BAYOU TERREBONNE DRAINAGE PROJECT

PHASE I: BAYOU CANE PUMP STATION

TPCG PROJECT NO. 17-DRA-42

ADDENDUM NO. 1

S24

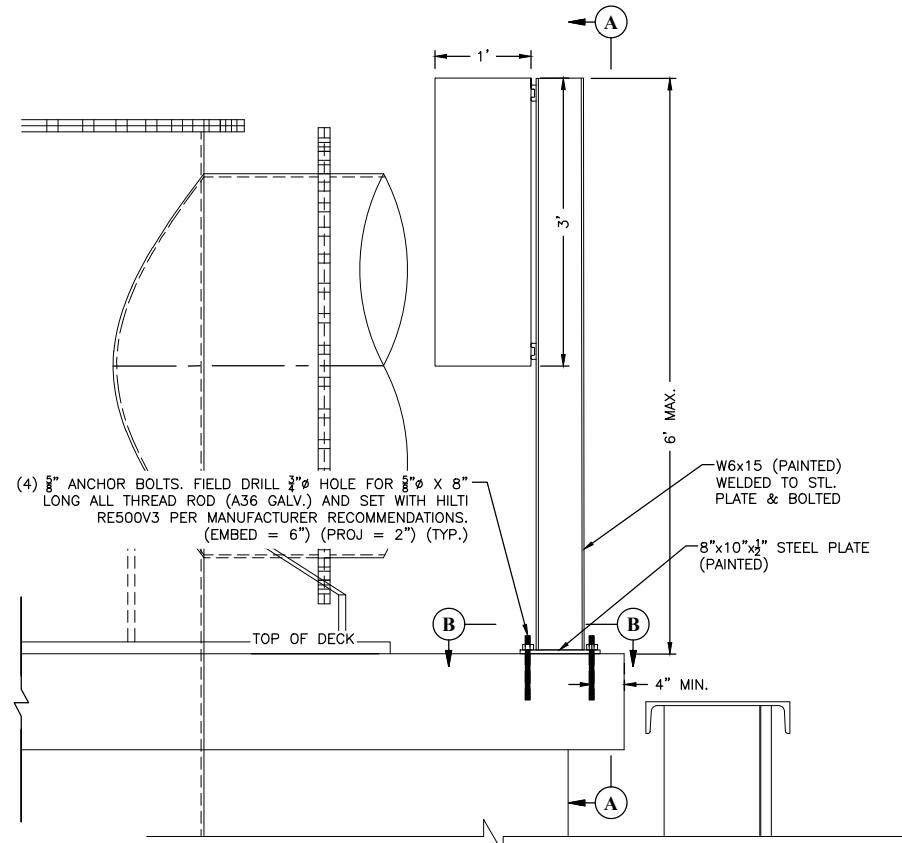
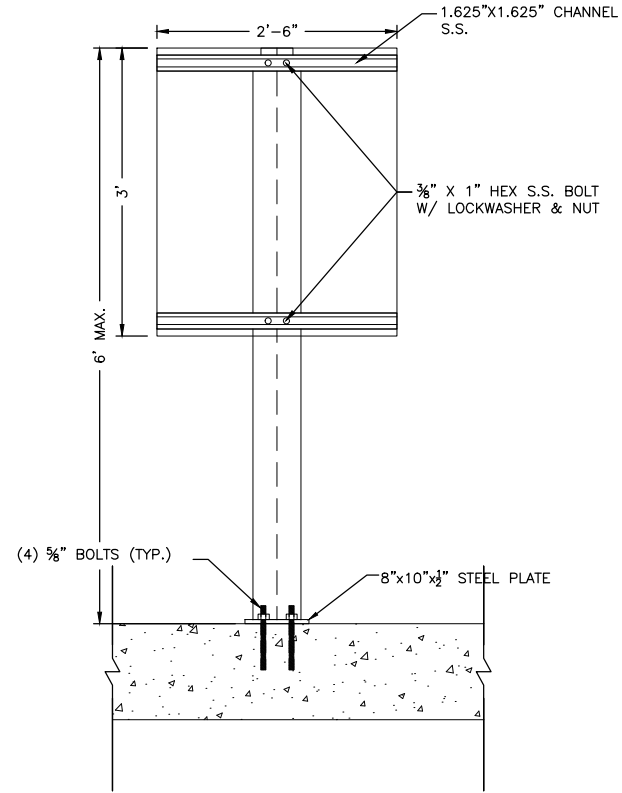
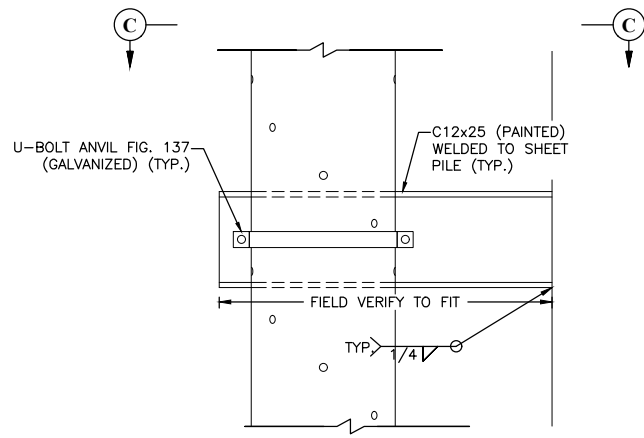
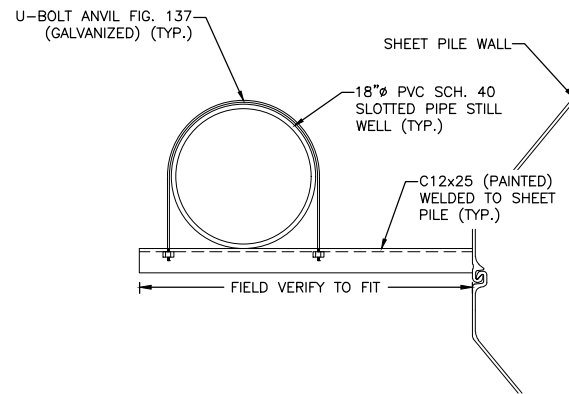
9. *Plan Sheet S24 – MISCELLANEOUS STRUCTURAL DETAILS* has been added to the plan set to show still well strap details and electrical junction box mounting details. The new sheet is attached to this addendum and shall be included in the plan set.

E1.1

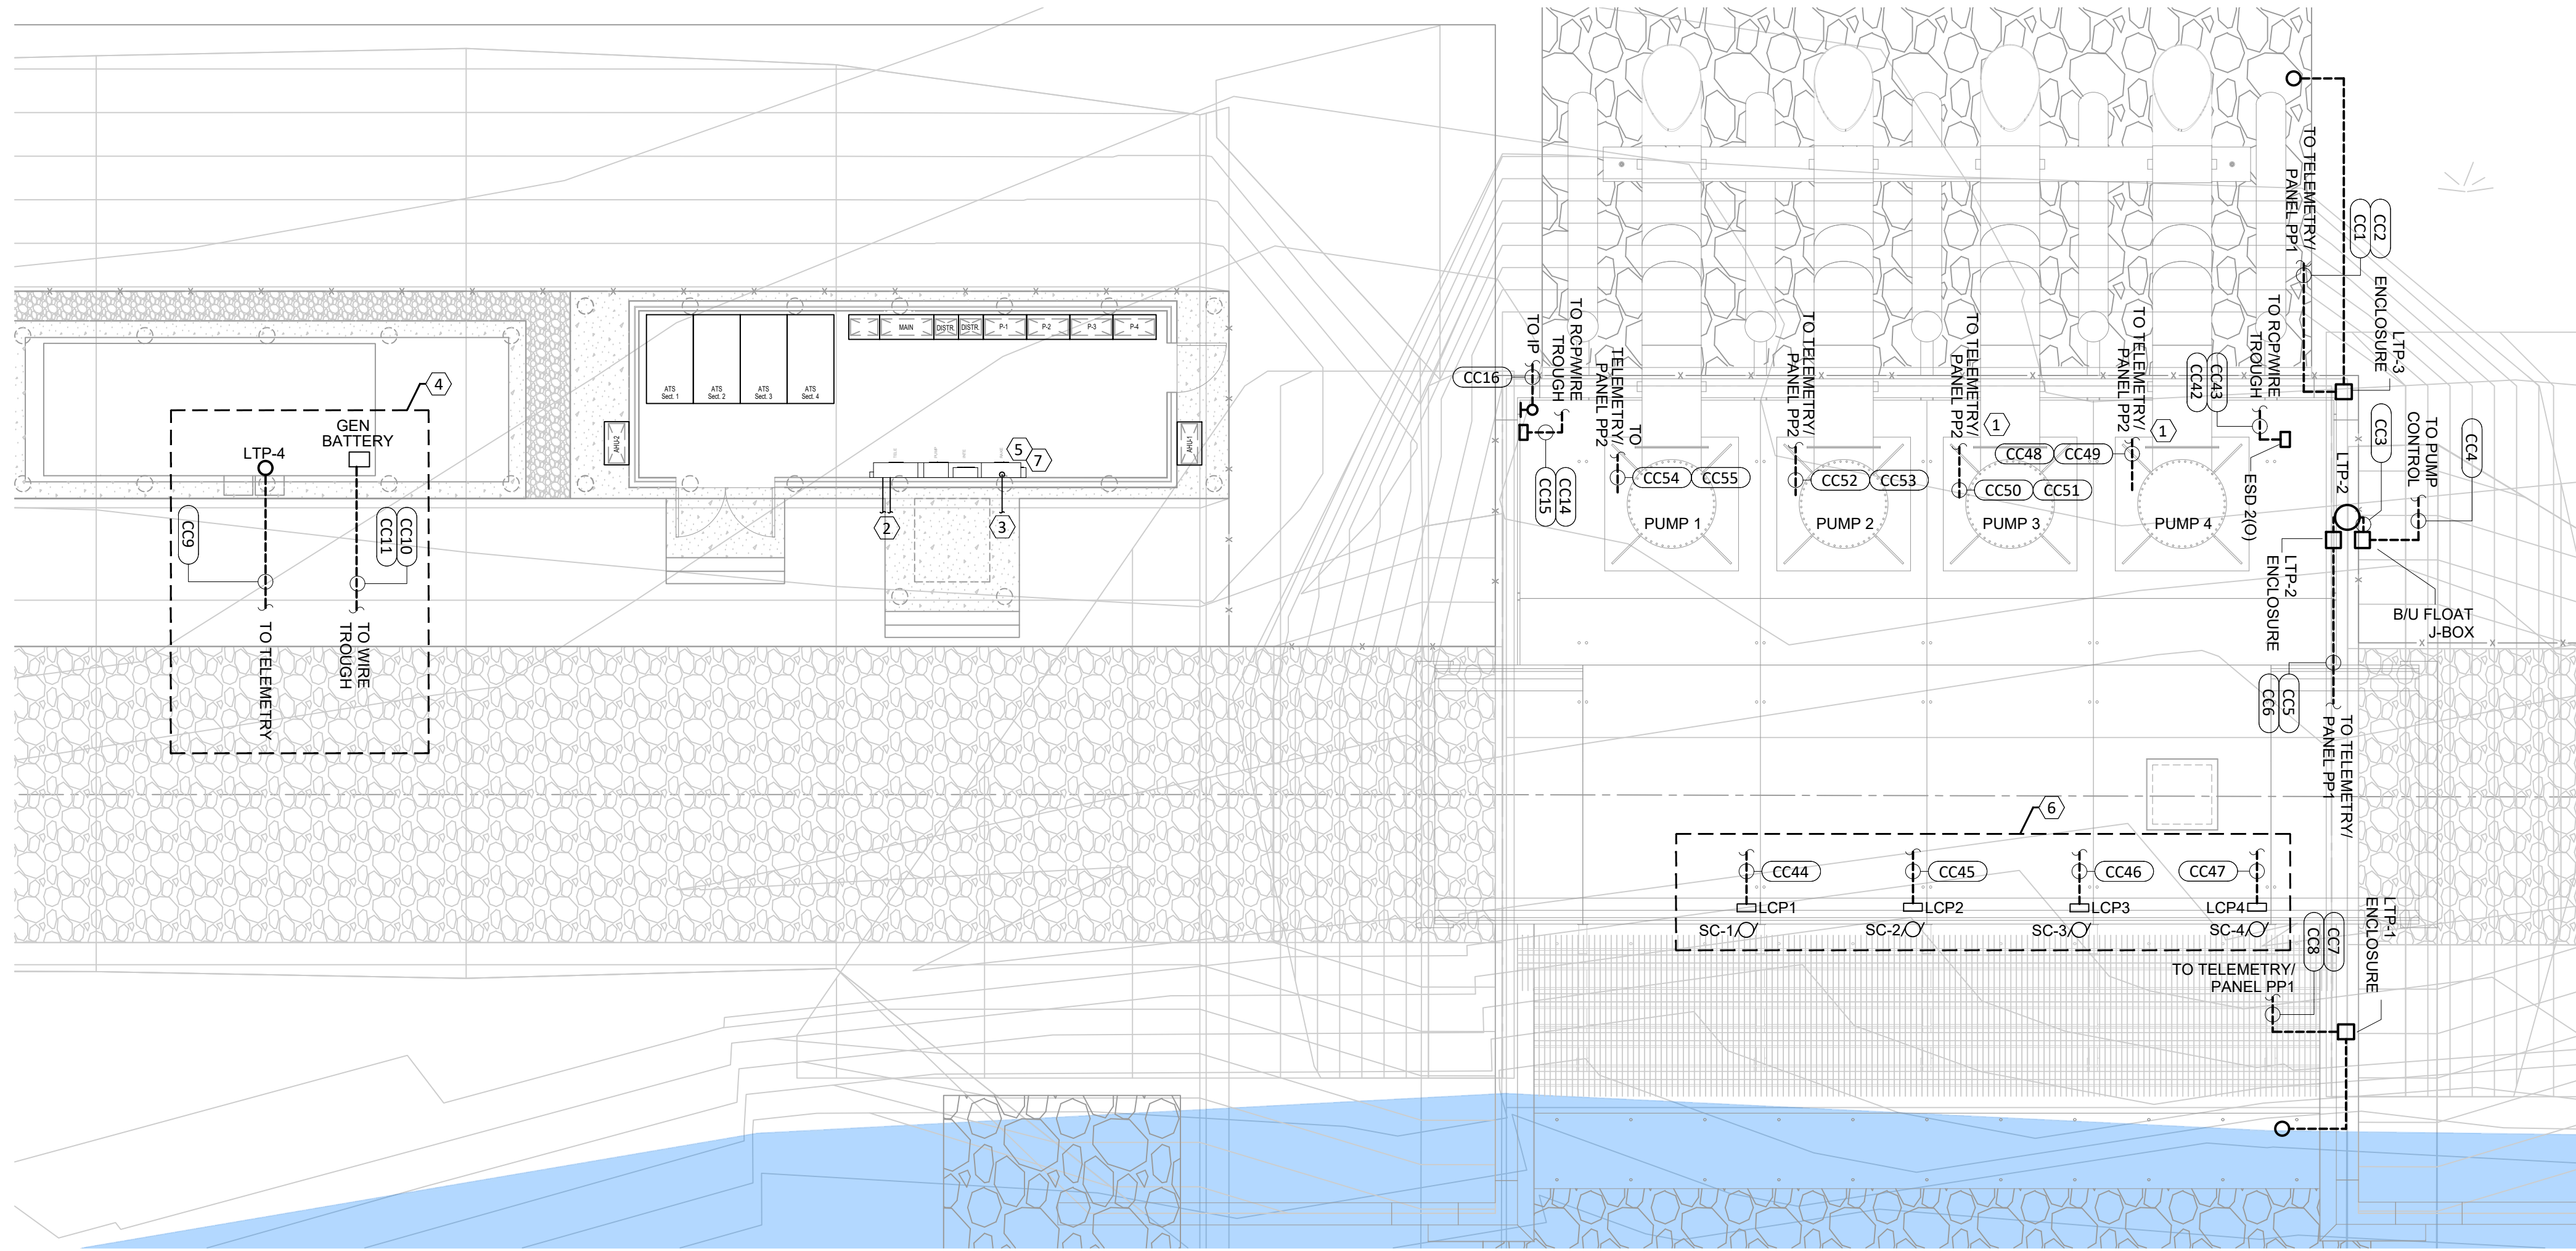
5. Drawing E1.1, Specific Note 7 is listed under Alternate #1. Is this a typo and should fall under Bid Ref. # E-04?

Response: Note has been revised on plan sheet M1.0 which is attached to this addendum. All HVAC units shall be included in the base bid.

ELECTRICAL RISER DIAGRAM

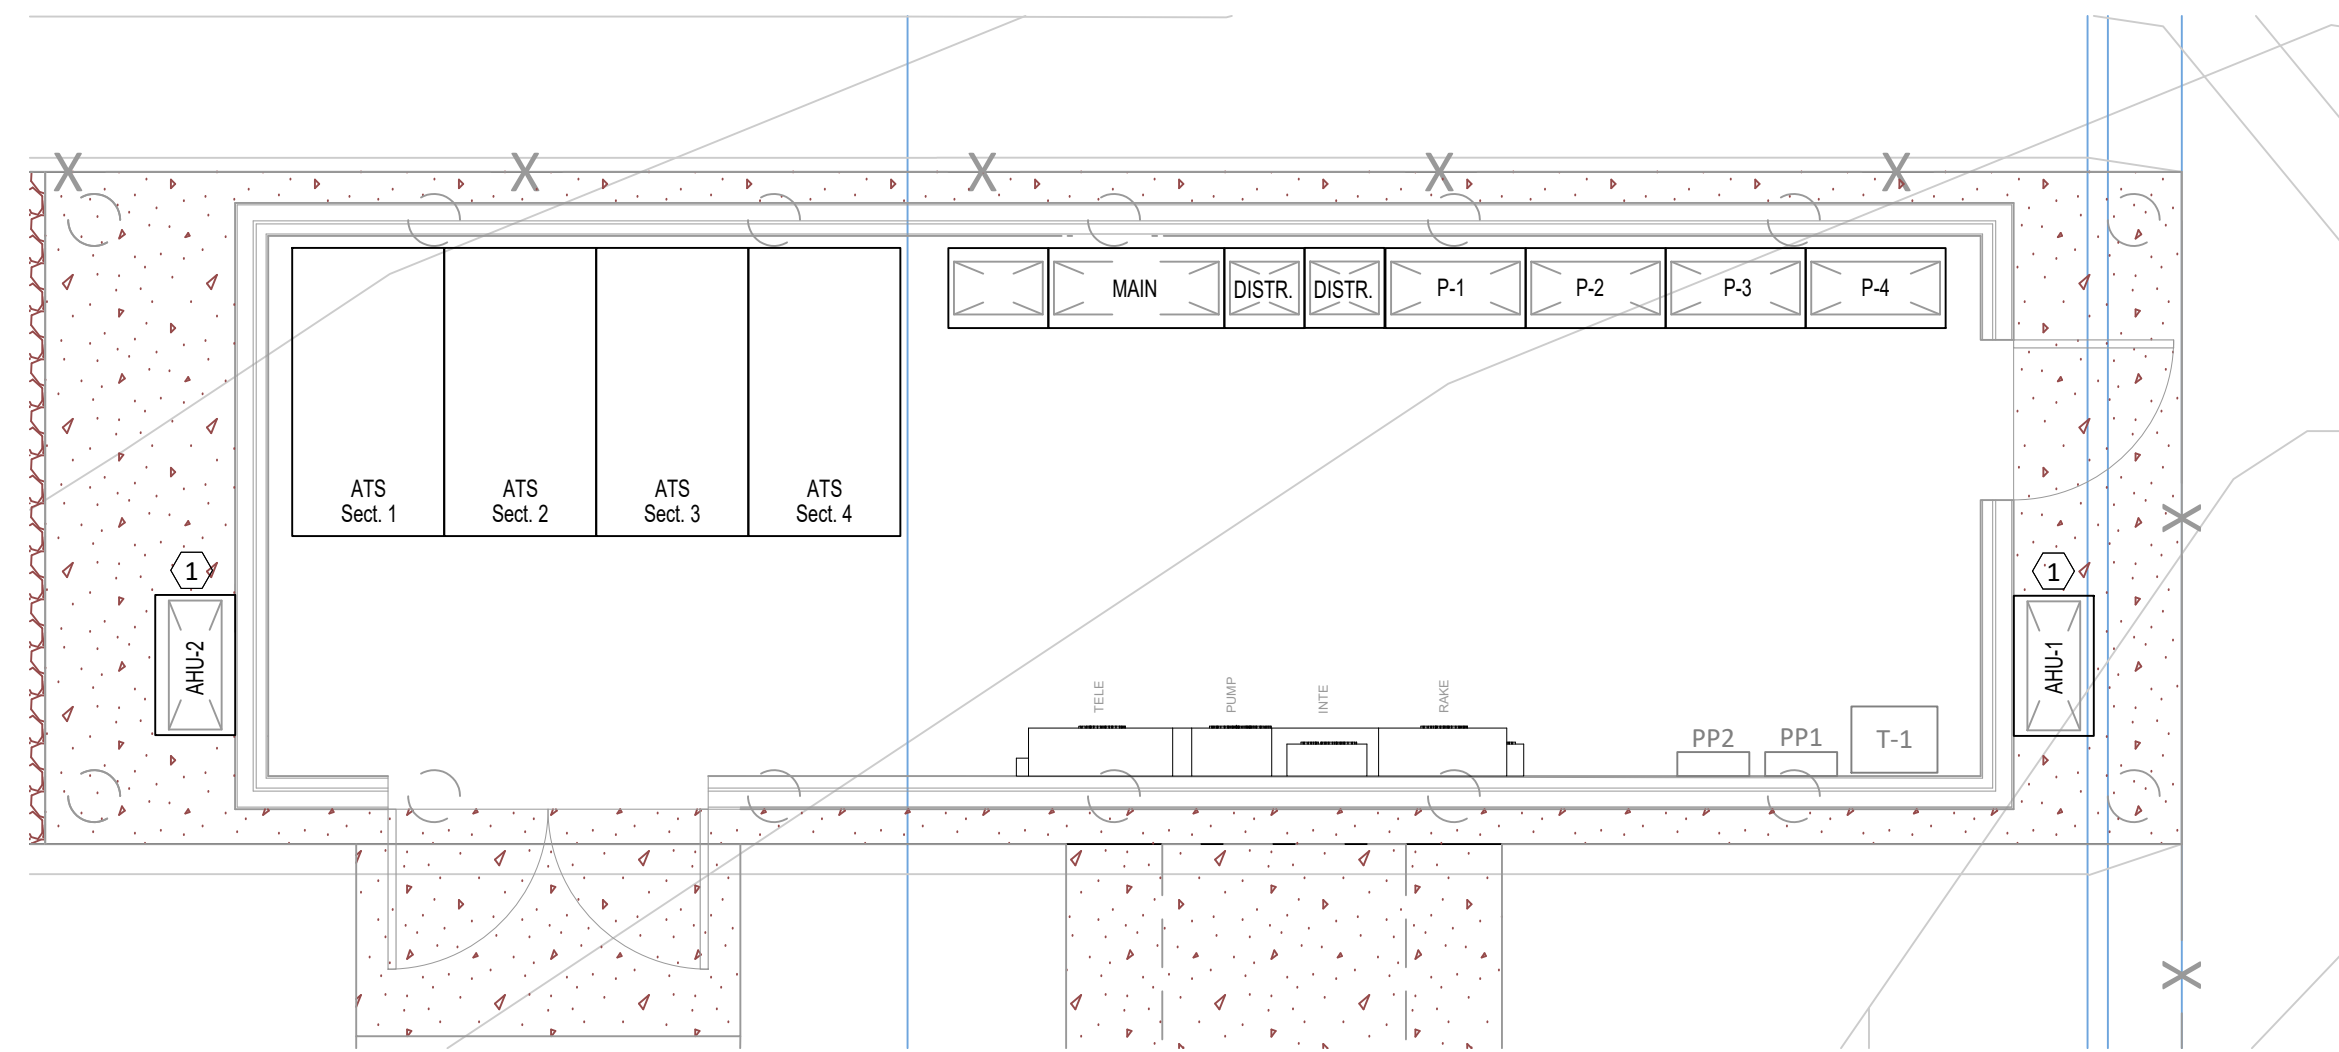
3. On drawing E1.3 the feeders to the ATS, MCC, GENERATOR and PUMPS are one size and on drawing E2.0 the same feeders are a different size, which drawing is correct?

6. Drawing 2.0 Specific Notes 16 calls for 9 sets of (3-600's) between the 3000A rated ATS and the 3000A rated MCC. 9 sets of 600's equate to 3780 amps. Is it acceptable to reduce the number of parallel feeders to 8 sets of 600's which equates to 3360 amps or 7 sets of 750's which equates to 3325 amps?

11. *Plan Sheet E2.0 – ELECTRICAL RISER DIAGRAM* has been revised. The revised sheet is attached to this addendum and shall govern and replace any previous versions.

Response: The POWER CONDUIT AND CABLE SCHEDULE identifying CONDUIT NUMBERS PC1-PC17 on Plan Sheet E1.3 is to be disregarded. Refer to the Electrical Riser Diagram or One-Line Diagram on Plan Sheet E2.0 for requirements. Please refer to the revised Plan Sheet E2.0 that is included in this Addendum.

Response: Conductors specified in Specific Note No. 16 are aluminum rated for 3,060 amps.
